NUCLEAR ENERGY INSTITUTE

SUBJECT: Transmittal of Comments on draft Regulatory Guide
DG-1144 and Revision 1 of MRP-47

**Comments on
DRAFT REGULATORY GUIDE DG-1144,
“GUIDELINES FOR EVALUATING FATIGUE ANALYSES
INCORPORATING THE LIFE REDUCTION OF METAL COMPONENTS
DUE TO THE EFFECTS OF THE LIGHT-WATER REACTOR
ENVIRONMENT FOR NEW REACTORS,” JULY 2006.**

Figure 1. Issue of Transient Linking

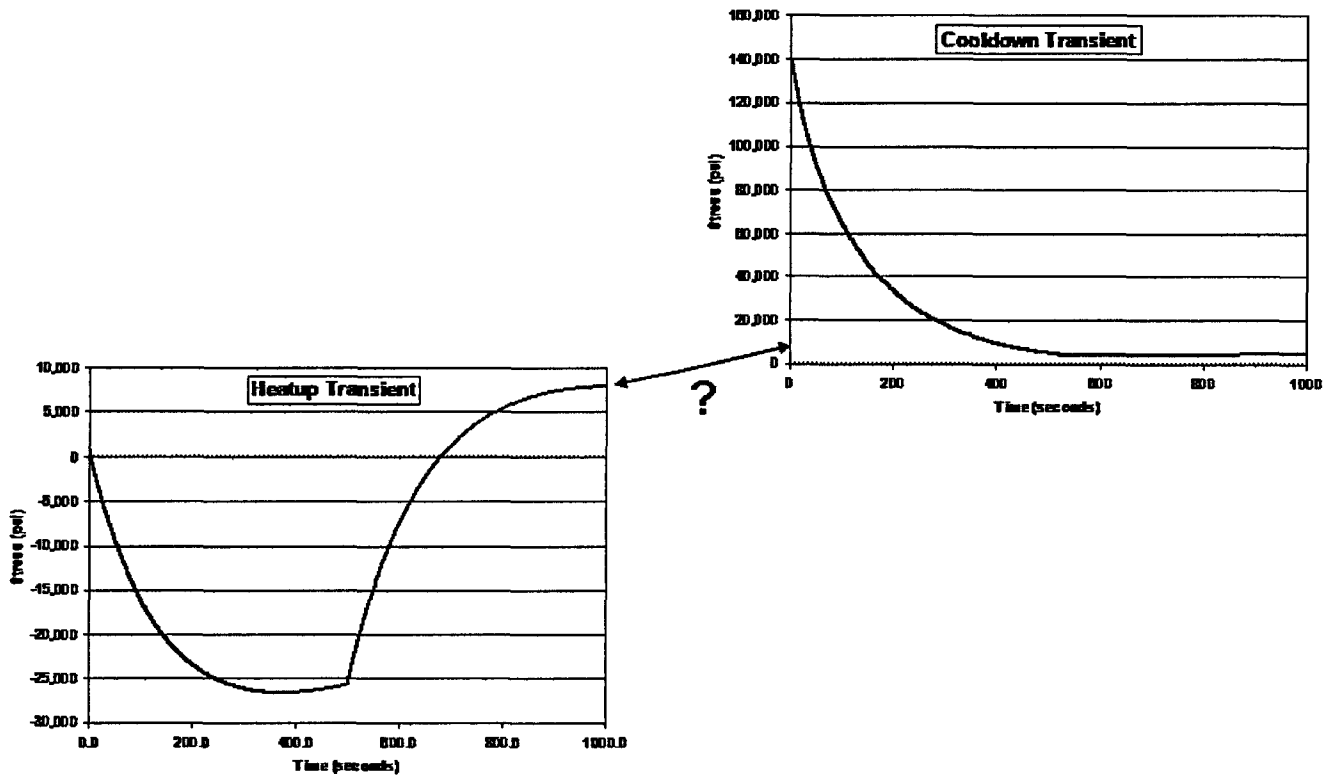
- a. "Linking" of transients pairs is not straight-forward and can lead to significant differences in results (refer to Figure 1). The MRP thinks that the recommendations made in Section 4.2.2 of MRP-47, Rev. 1 are an acceptable means of addressing linking of transients with respect to:
 - Situations where the starting and ending stress points between two linked transients are not equal.
 - Establishing the rate of change for the discontinuity between linked transients.
 - Computing the strain rate for linked transients.

Please revise the text of DG-1144 to state that the recommendations made in Section 4.2.2 of MRP-47, Rev. 1 are an acceptable means of addressing linking of transients, or provide alternate recommendations.
